UNITED STATES PATENT AND TRADEMARK OFFICE

Office Action Summary	Application No. 10/749,040	Applicant(s) BURLESON, MICHAEL ALLAN	
	Examiner Stephen D'Adamo	Art Unit 3636

DETAILED ACTION

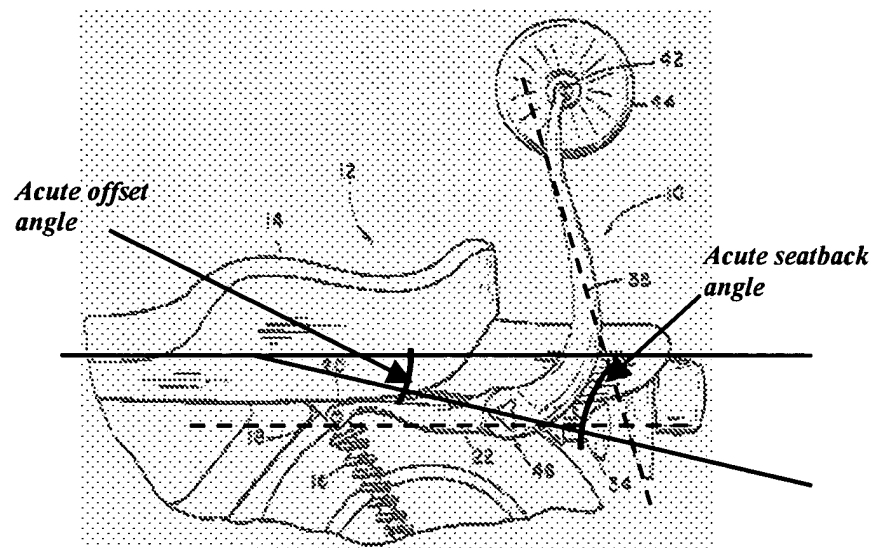
Ware discloses a motorcycle backrest comprising a seatback 10 having an upright position and a boarding position, as seen in Figures 2 and 4. The seatback also includes a rotational means 46 for revolving the seatback between the upright and boarding position and a latching means 48 for retaining the seatback in an upright position. Further, a

mounting means for attaching the seatback to the motorcycle. The rotational means 46 is attached between the seatback and the mounting means. As seen in the Figure below, Ware also teaches of an extended longitudinal axis which lies between the top and bottom of the seat and aligning generally with the direction of travel of the motorcycle. The rotational axis also intersects the extended longitudinal axis at an acute offset angle.

Regarding claims 5-7, the seatback also comprises a seatback plate having an upper section or support arms 38, 40 and a lower section or frame arms 22, 24. A pad 44 is attached to the upper section 38, 40. As seen in the figure below with the dashed lines, there is an acute seatback angle measured between the upper and lower sections. The rotation means is attached to the lower section of the seatback plate. Moreover, the sum of the offset angle and the seatback angle is less than 120 degrees.

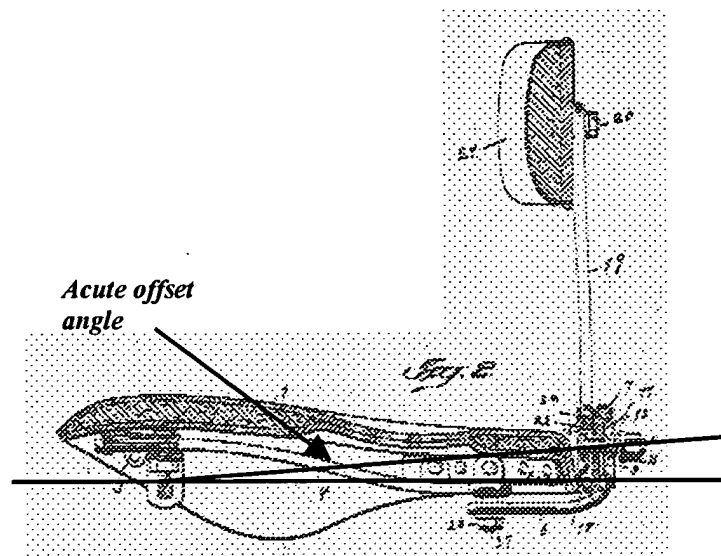
Mesinger discloses a saddle for motorcycles comprising a seatback 27 having an upright position and a boarding position (Figure 4), rotational means for revolving the seatback between the upright position and the boarding position. Further, Mesinger teaches of latching means 24, 25 for retaining the seatback in an upright position and mounting means 6 for attaching the rotatable seatback to the vehicle. The rotational means is attached between the seatback 27 and the mounting means 6. Mesinger also teaches of an extended longitudinal axis which lies between the top and bottom of the seat and aligning generally with the direction of travel of the motorcycle. The rotational axis also intersects the extended longitudinal axis at an acute offset angle.

With respect to claim 9, the rotational means comprises a swivel plate 11, a swivel 19, and a swivel pin 10. The swivel is received by the swivel plate 11 and held within the swivel plate by the swivel pin 10. The swivel freely rotates within the swivel plate providing the latch mechanism 24, 25 is not engaged.

Regarding claim 18, as seen in the Figure below, the offset angle is less than 20 degrees and greater than 0 degrees.
